**CITY OF HANOVER
PLANNING COMMISSION MEETING
MAY 23, 2018
OFFICIAL MINUTES**

a. Environmental Assessment Worksheet (EAW) for Crow River Heights West Future Additions

b. Planned Unit Development and Preliminary Plat for Crow River Heights West Future Additions

Outlet B,
Wetland 11

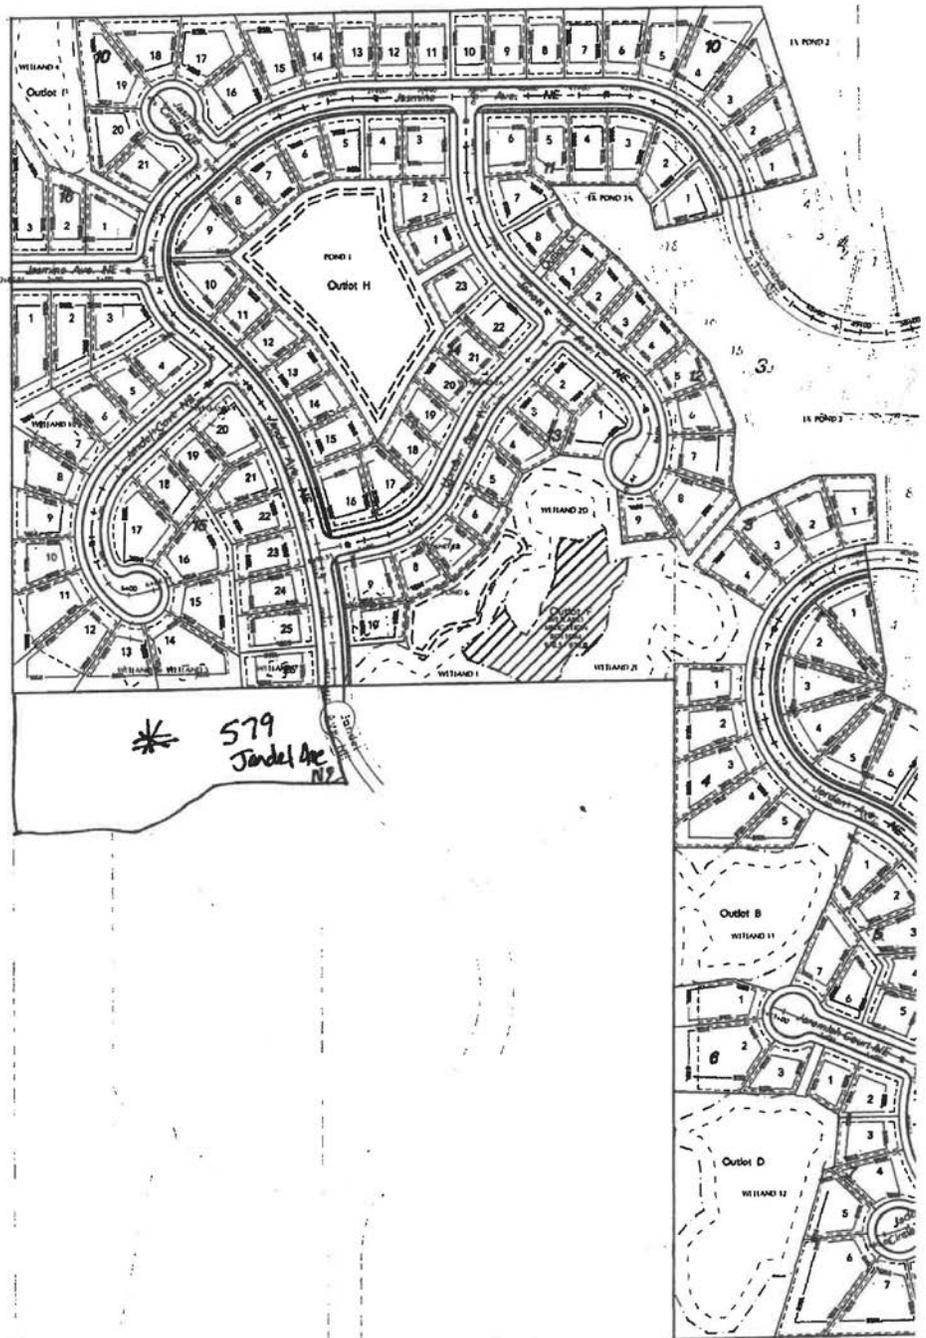
The platted area abuts our property located at 538 Jandel Ave NE, Hanover (Whitetail Preserve). We attach a photo with our lot outlined in blue and the Crow River Heights West area to the east.

In this phase, our area of interest is Outlot B, Wetland 11 of 41,815 sf. This wetland does not physically stop at the development lot lines, rather the actual wetland extends in to our lot. This wetland has seasonal flooding with high water that flows and extends to wetland areas along and in to our east lot line. This extended flow creates seasonal flooding. Per documents, it appears this Outlot B, Wetland 11 is planned to be unmitigated. However, as mentioned in the Wetland Delineation Report page 111, "the wetland has expanded since the time of the previous delineation into the adjacent graded area".

Our concern is knowing if no mitigation will be maintained, or if any mitigation and/or alterations are contemplated that affect this wetland and what protections will be in place during this phase, during home construction, and during homeowner lot work regarding landscaping or water management they may do.

As this Wetland 11 physically extends in to our lot, our interest and expectation is to not create any additional seasonal or non-seasonal high water to our property related to this development – whether through grading, drainage, water runoff, during site work, home construction, and/or homeowner landscaping and water management. This considers Chapter 20 - Zoning Ordinance and Chapter 30 - Subdivision Ordinance and/or other Chapters that may apply. If such conditions were to occur, we would expect mitigation be undertaken by the developer and/or the appropriate Crow River Heights West homeowner(s).
